## Certified Action of the City of Raleigh Planning Commission

**Case File / Name:** S-39-10 / Edwards Townhomes Lot 4

**Nature of Case:** Subdivision of .300 acres into 3 townhome lots zoned Residential-10.

## Staff Report

S-39-10 Edwards Townhomes lot 4 - subdivision plan

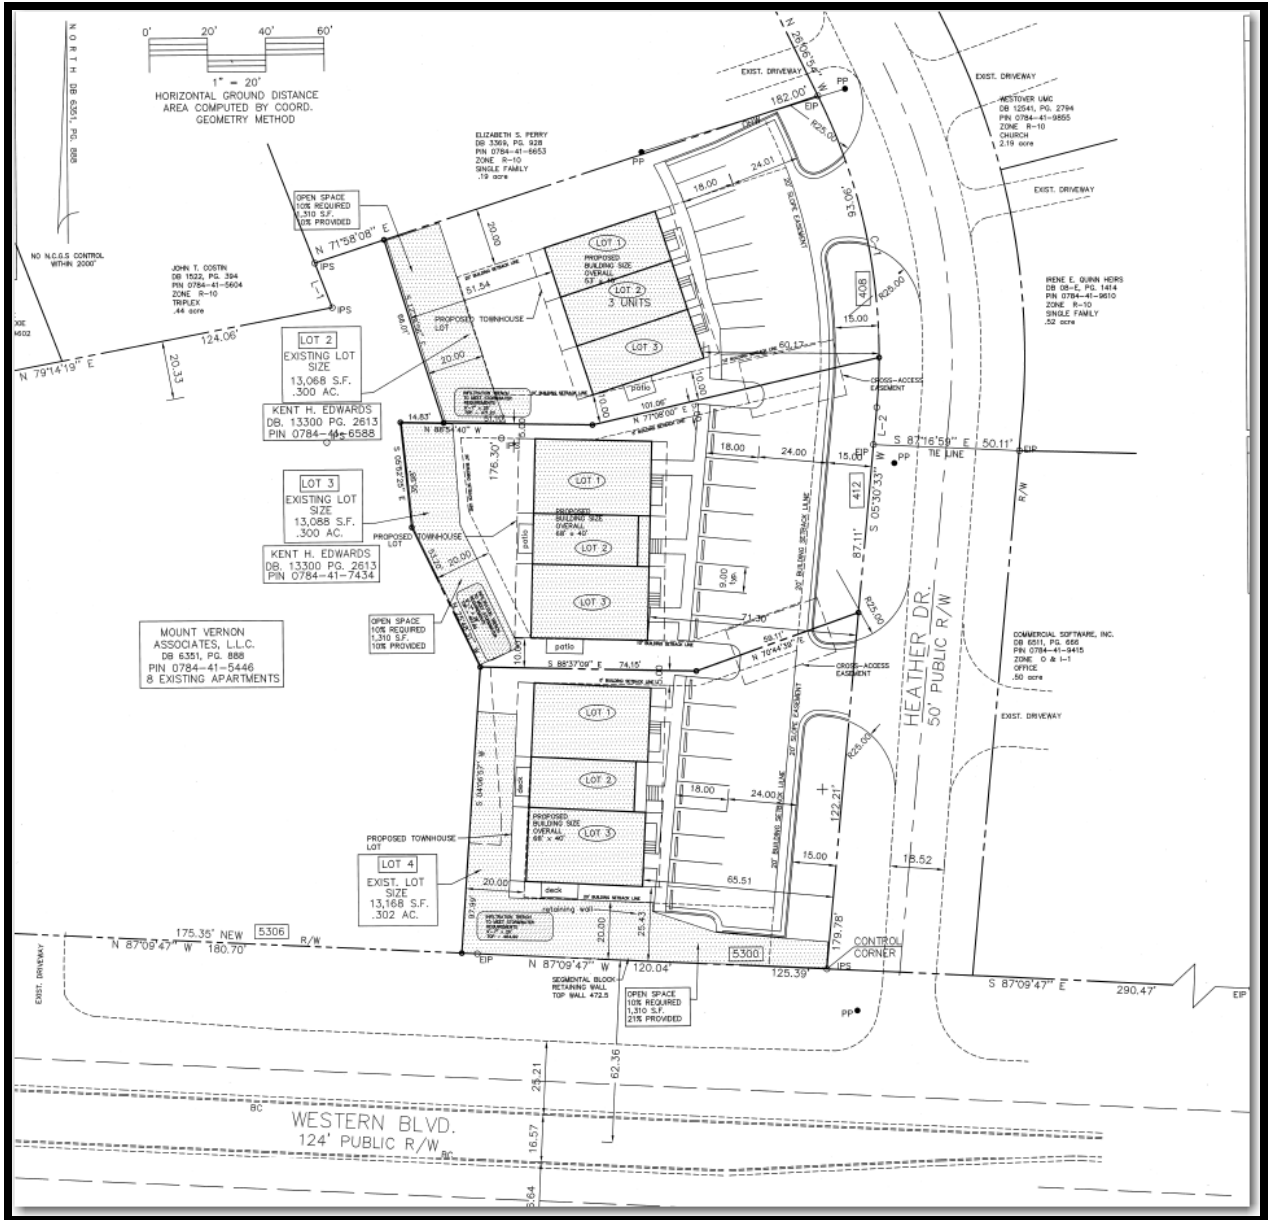
- (1) That the Planning Commission finds that this subdivision meets the site plan approval standards of Code section 10-2132.2(d).
- (2) That the Planning Commission finds that the standards of Code section 10-2103(h) have been met and that the proposed alternate design provides equivalent privacy, environmental, recreational, and safety benefits, and provides comparable utility and accessibility as the Code Standards;

- Additional landscaping between buildings will provide privacy. The additional landscaping will include a row of Leyland Cypress planted at 6' in height between buildings to give felling of privacy and separation for the homeowners. There will be windows on the sides of the buildings. As the new townhomes are constructed, the lot will be recombined eventually into 1 single lot with a total of 9 townhomes.

<u>Comment</u>	<u>Response</u>
1. The committee recommends that building materials to be used on the front facades be continued on all other sides [commensurate with Code Sec. 10-2132.2(d)(6)].	While the owner has not prepared the detailed elevation of all sides of the proposed building, be assured that all sides of the proposed buildings will be of similar design and materials as the front elevation.

2. If parking lot lighting is installed, scale pole height to pedestrian use and install low-glare, cutoff fixtures [commensurate with Code Sec. 10-2132.2(d)(3)].	The owner is not sure at this time if any pole lights will be placed in the parking area for the units. If pole lights are used, they will be low carriage style lights at 12'-16' ht..

3. Install site sidewalks at the time of site development rather than paying a fee in lieu [commensurate with Code Sec. 10-2132.2(d)(1) & (2)].	The City Transportation staff has indicated they would rather have a fee-in-lieu of construction of curb & gutter and sidewalks for Heather Drive. The owner is agreeable with the staff recommendation.

- (19) That the additional landscaping of Leyland Cypress planted at 6' in height between buildings shall be installed.
